**RE: Remediation Work Plan due to Closure denied
Malachite 22 Federal #002H
API No. 30-025-40389
GPS: Latitude 32.6520462 Longitude -103.6548004
UL "C", Section 22, Township 19S, Range 33E,
Lea County, NM
NMOCD Reference No. NTO1432553976**

Remediation Work Plan due to previously denied closure report

Raybaw Operating
API #30-025-40389
Lea County, NM
Horizontal Delineation Map

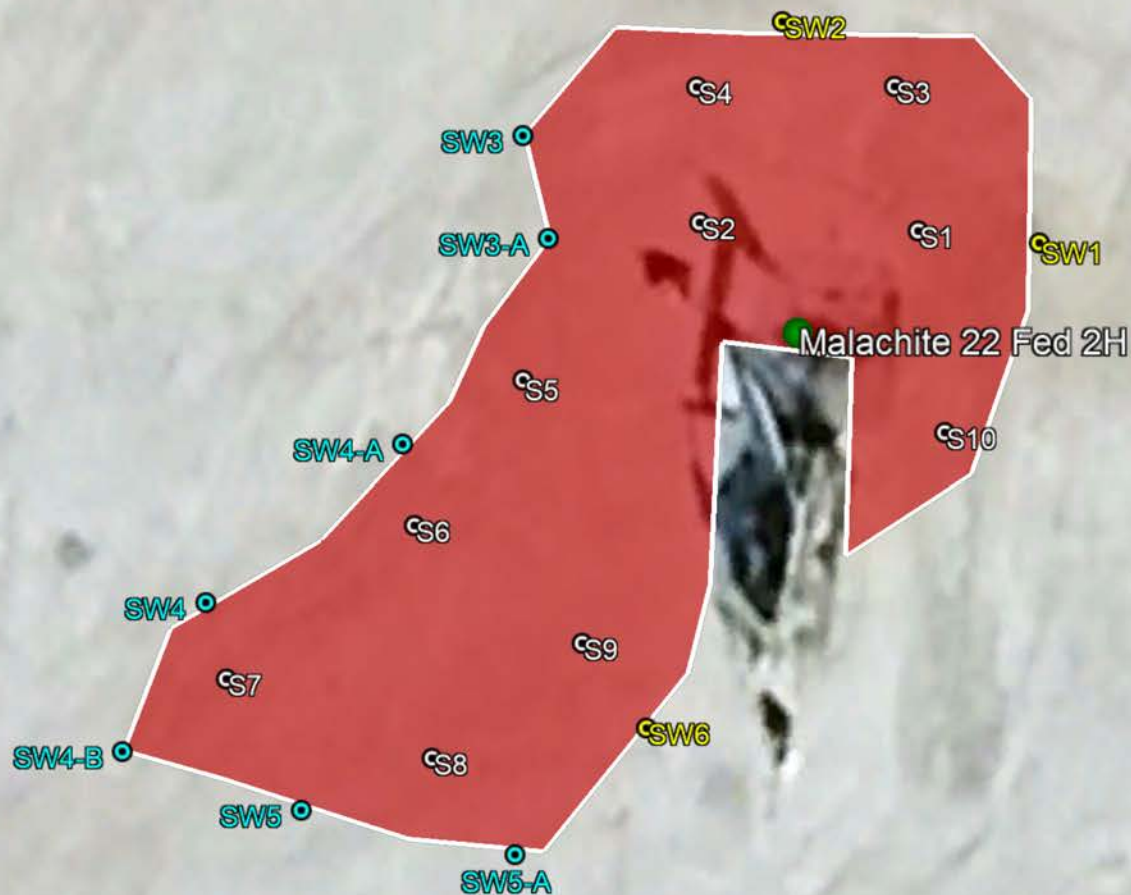
2. Collect 5-point composite samples from the blue sample points referenced on the Horizontal Delineation Map found in Figure 1. These sample points will include SW3, SW3-A, SW4-A, SW4, SW4-B, SW5, and SW5-A.

Attached is a new map that we came up with for clearly defining the horizontal extents of these areas. The latest data table is also included on page 2. Our plan is to collect 5-point composite samples from the blue sample points referenced on this map (SW3, SW3-A, SW4-A, SW4, SW4-B, SW5, SW5-A). The 5-point composites will be comprised of Surface, 1', 2', 3', and 4' samples collected from each sample point. Samples will be field tested for contamination, if any exists the sample points will be recollected from another sample location further away from the spill area. This process will be repeated for each sample point until delineation can be achieved. The final 7 additional composite samples will be delivered to the lab for official testing.

In reference to incident NJXK1523052658, application ID 280818, the release area has not been fully delineated and therefore OCD cannot determine if the release traveled to areas not reasonably needed for production or subsequent drilling operations. Horizontal delineation must meet the requirements of the reclamation standards 19.15.29.13 NMAC (600 mg/kg Cl, 100 mg/kg TPH, 50 mg/kg BTEX, 10 mg/kg benzene) or OCD approved "background" values for the upper 4 feet of the impacted area. Samples collected for SW1-SW6 extend to only 1-foot bgs. Sample S7 @3 feet and samples S8 @1 and @2 exceed reclamation standards 19.15.29.13 NMAC (600 mg/kg Cl, 100 mg/kg TPH, 50 mg/kg BTEX, 10 mg/kg benzene) and therefore require additional horizontal delineation.

1. A 48 hour sampling notification will need to be submitted.
2. Include photos and GPS locations of samples in final report.

Created By	Condition	Condition Date
amaxwell	Work plan approved with the following conditions: 1) A 48 hour sampling notification will need to be submitted. 2) Include photos and GPS locations of samples in the final report.	11/14/2023
amaxwell	Submit final report by December 29, 2023.	11/14/2023
